TR-5310-1
REVISION 2

MARK I CONTAINMENT PROGRAM

PLANT-UNIQUE ANALYSIS REPORT
OF THE
TORUS SUPPRESSION CHAMBER
FOR
PILGRIM STATION - UNIT 1

TECHNICAL REPORT TR-5310-1
REVISION 2

FIG. 2-II

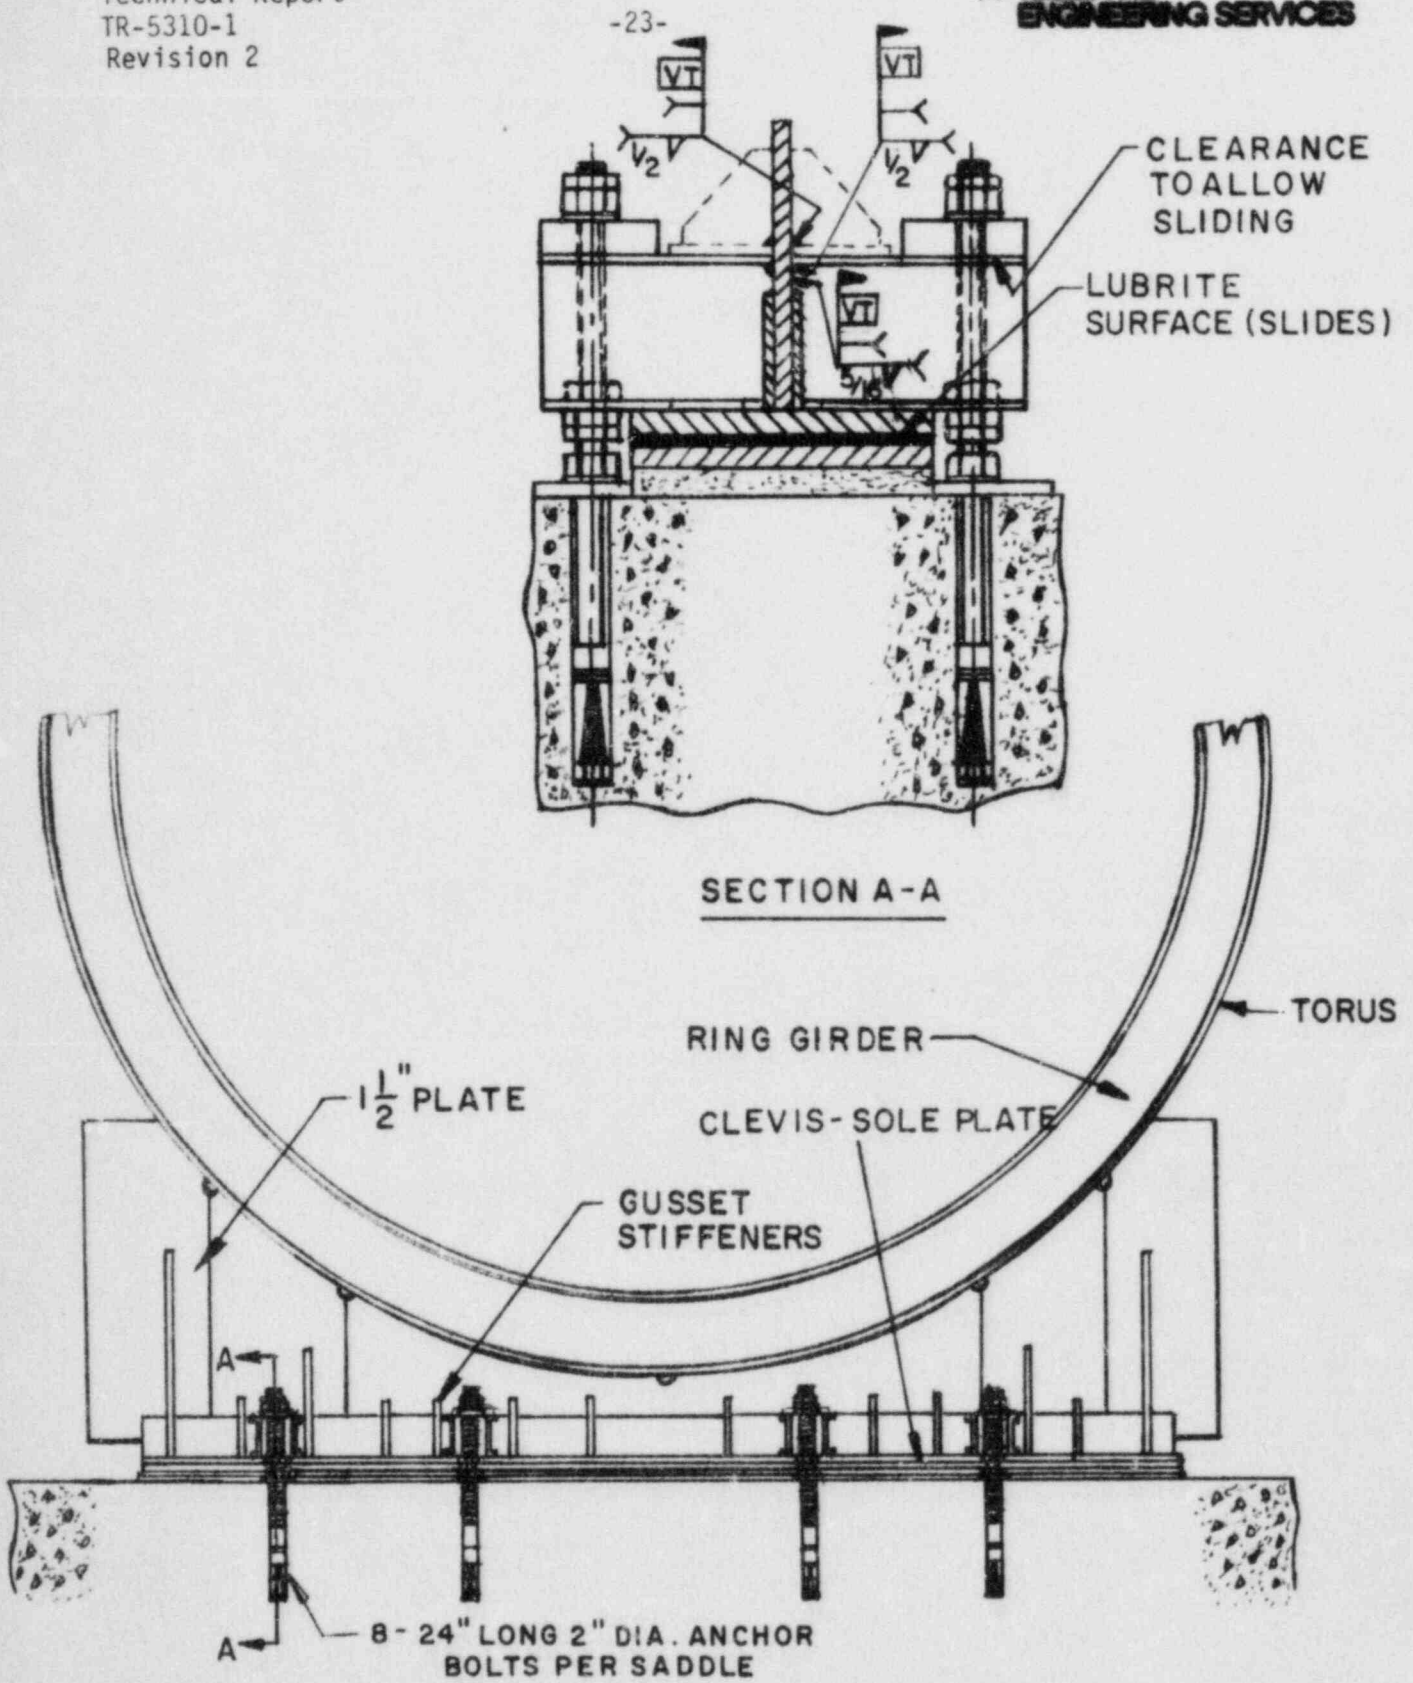
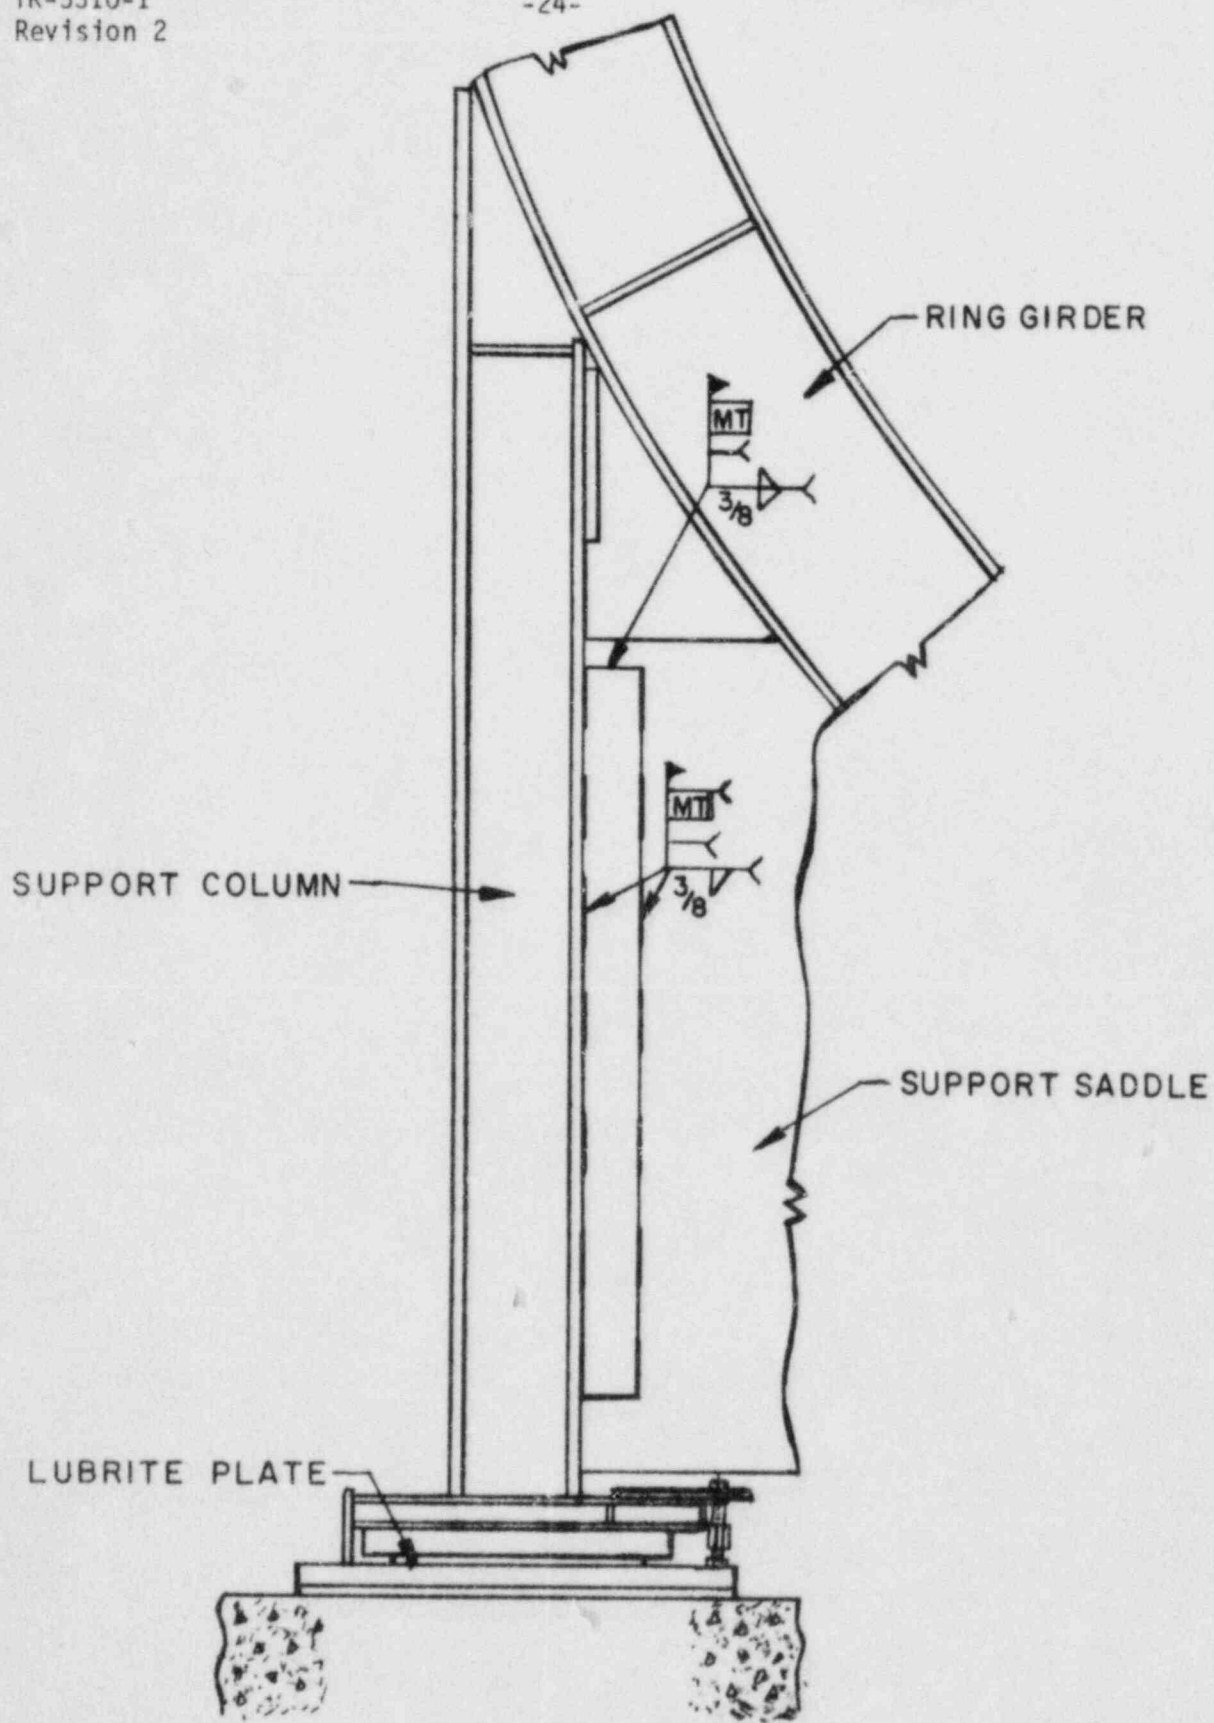
With regard to the finite element model of the torus, including the shell, ring girders and supports, it is not clear whether the saddle webs and the torus columns were welded together as shown in Figures 2-5, 2-11, 2-12, 3.1, and 3.2 (2). Provide information showing the as-built configuration of the torus and its supports.

Assembly Drawing E-5110, Rev. 4 (Sheet 1 of 2) which shows the actual saddle web and column support geometry.

FIGURE 3.1 DETAILED SHELL MODEL

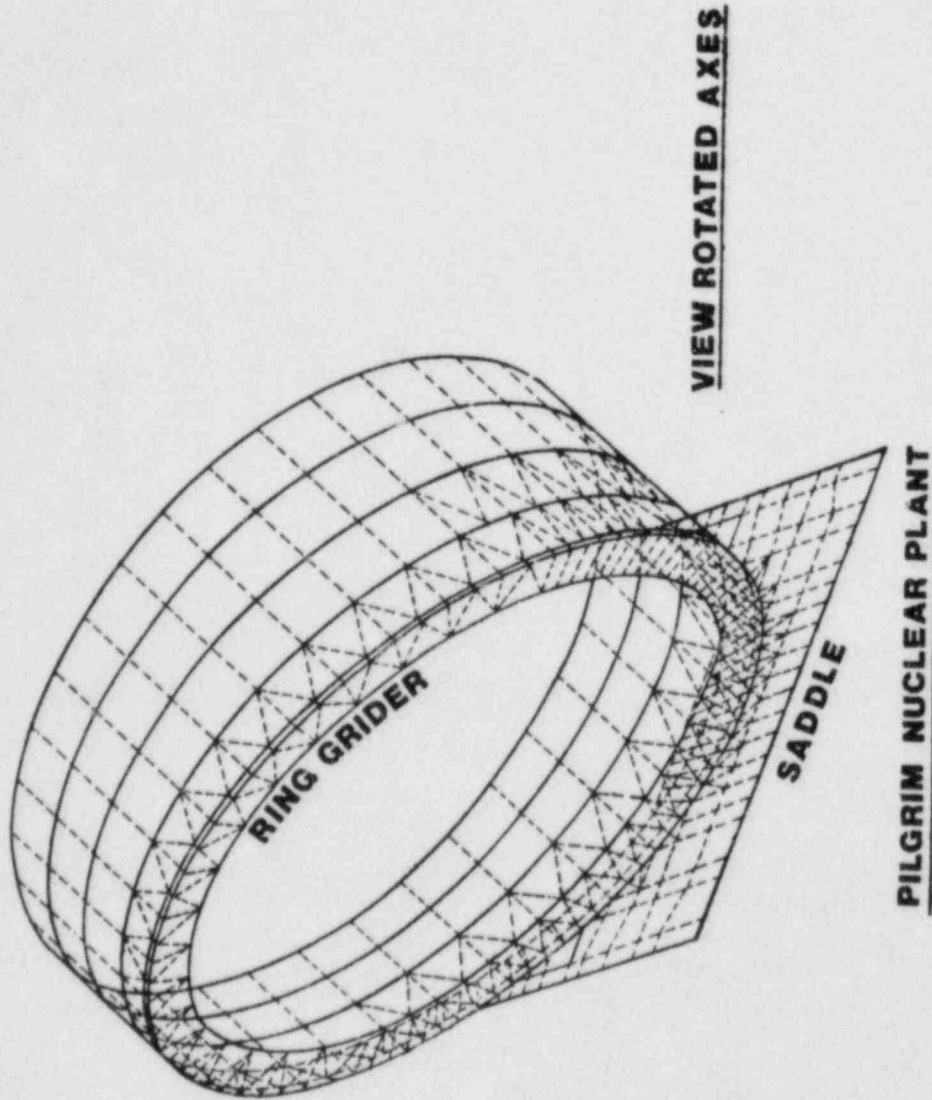
With reference to the computer model for the 1/32 segment of the torus shown in Figure 3-1 of Reference 2, and the analysis performed using only

Revision 2, ^{A4.2-16} symmetric boundary conditions, provide justification for not considering skew symmetric boundary conditions in order to evaluate the effect of the resulting modes.

FIG. 5-1
RING GIRDER - PILGRIM

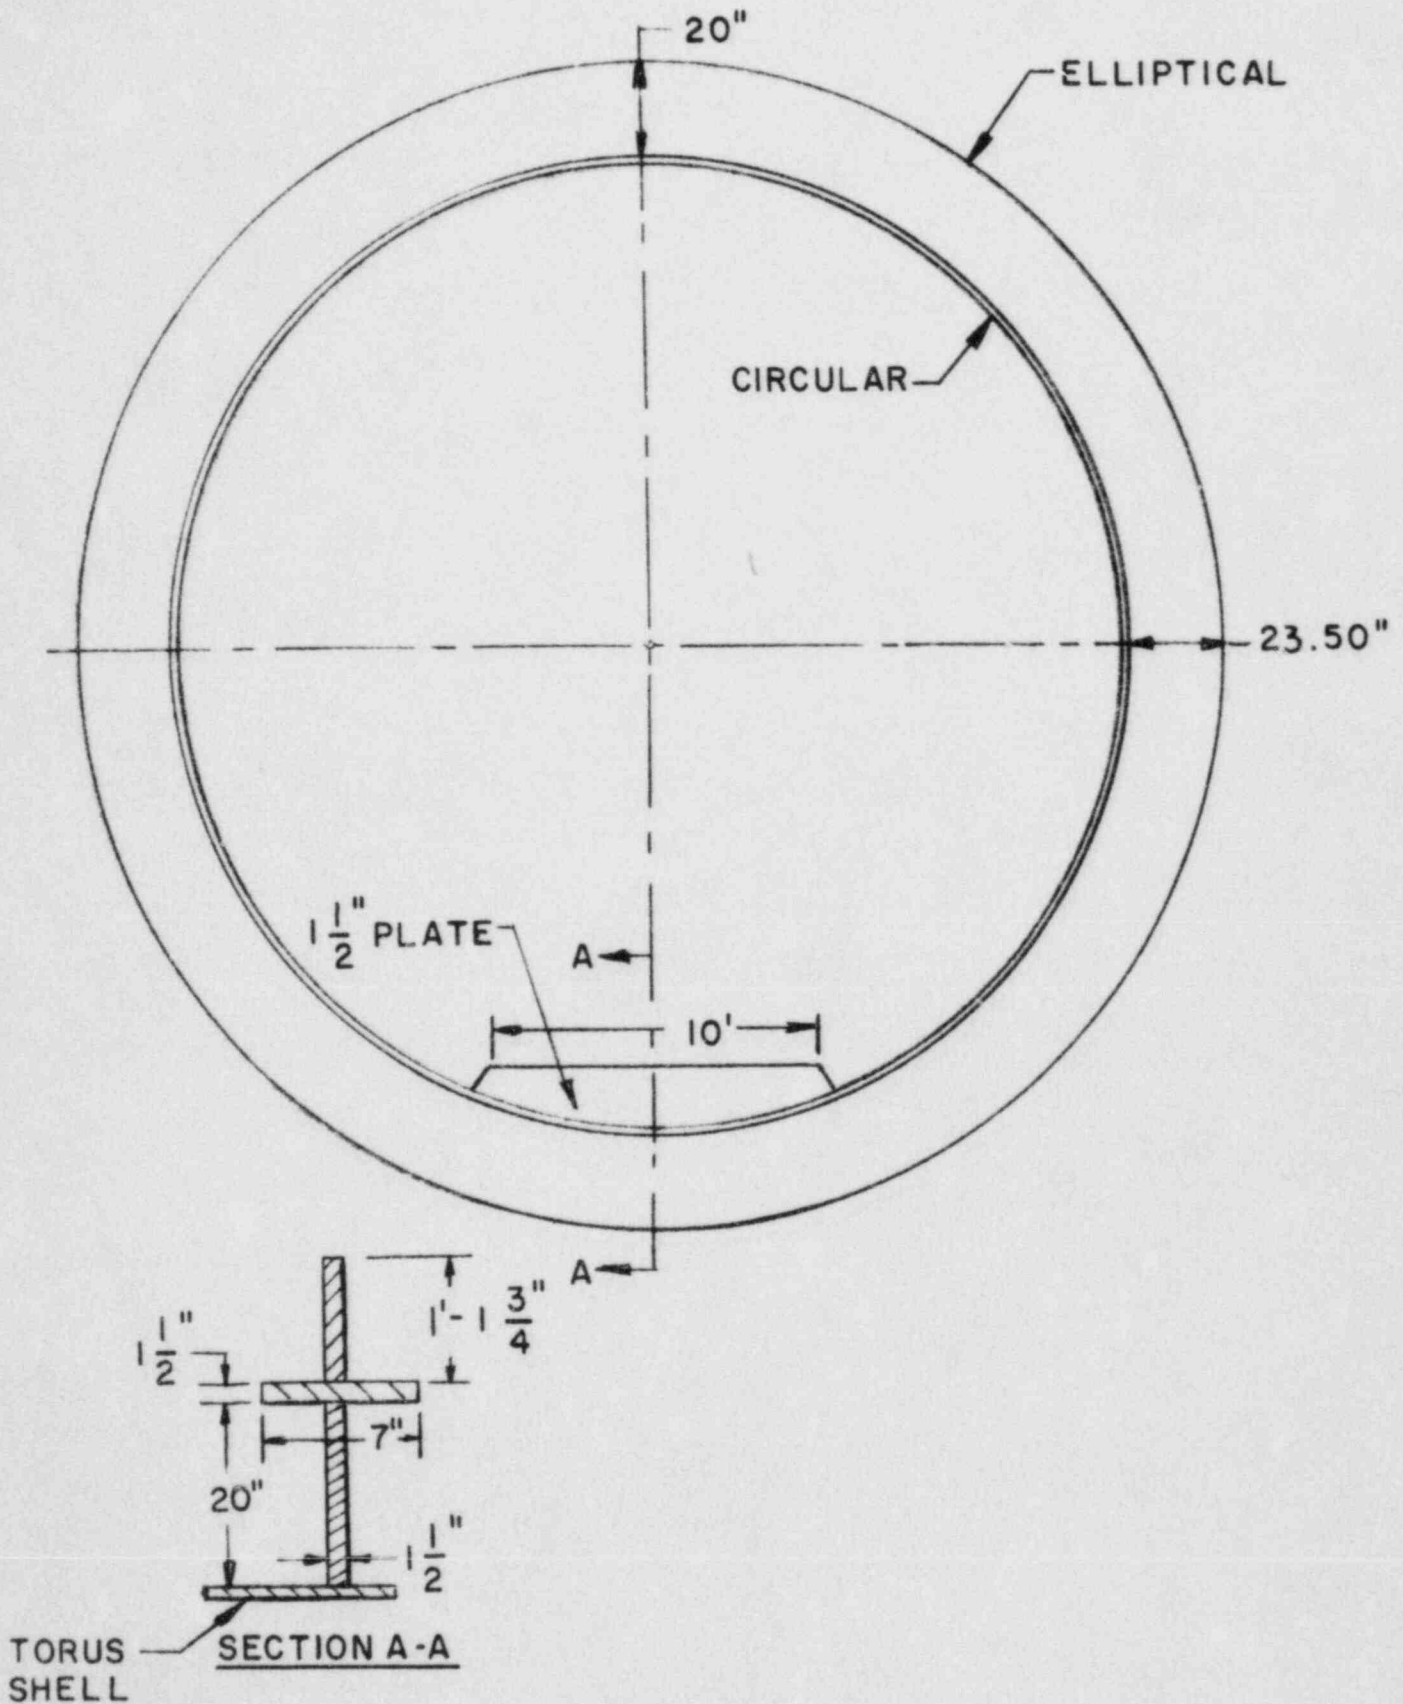
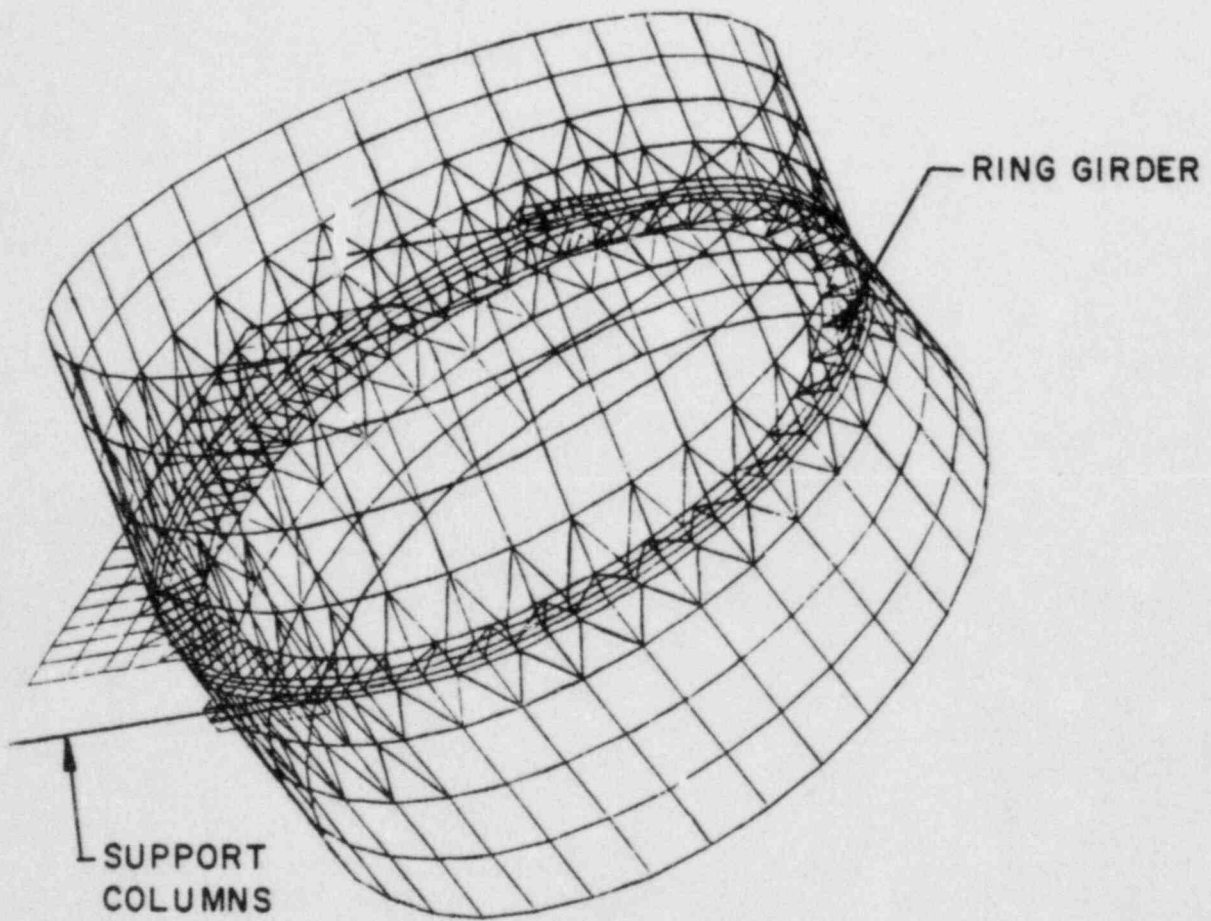
With regard to the ring girder model, the dimensions shown in Figure 3.3 (2) seem inconsistent with the dimensions shown in Figure 5-2 (2). Provide information showing the dimensions of the ring girder.

Figure 5-1 contains the ring girder dimensions, one of which is in error. The 20.50 inch ring girder web dimension should be 23.5 inches. We are including an uncontrolled copy of the Pilgrim CB&I drawing, numbers 50 and 52, which contains the dimensions in question. This is an illustration error that does not affect analysis.
